Underground Cost Analysis; Option 10 and 11 - TRTP Project

Project Segment 8A Corridor

SCE Cost Overview on Option 10 (Single Circuit XLPE 3 Cables per Phase) and Option 11 (Single Circuit XLPE 2 Cables per Phase)

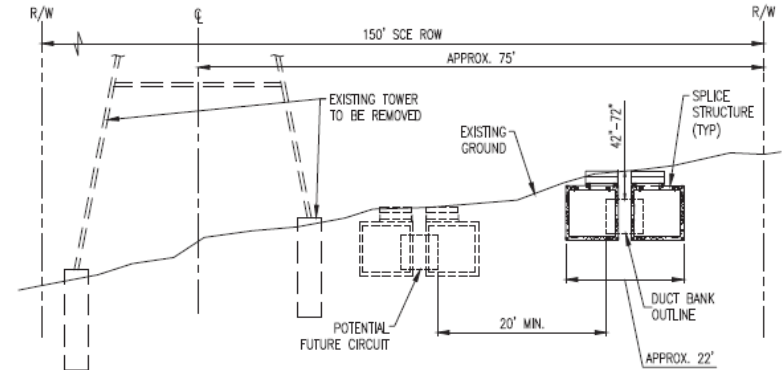
Attachment W, reflect a schedule duration for engineering of approximate 25 months to . Hereto, SCE appears to bias the approach. Specifically, there are many steps that can be taken to mitigate the schedule duration. In our Opinion the **engineering effort can be completed within 14 months**. Key steps to accelerate the engineering schedules are shown below.

- Engineering
 - Advance concepts and preliminary engineering concurrently with environmental and permitting effort
 - Preliminary and detail design effort can be completed in 12months and start immediately
 - A design-build approach can also reduce the duration
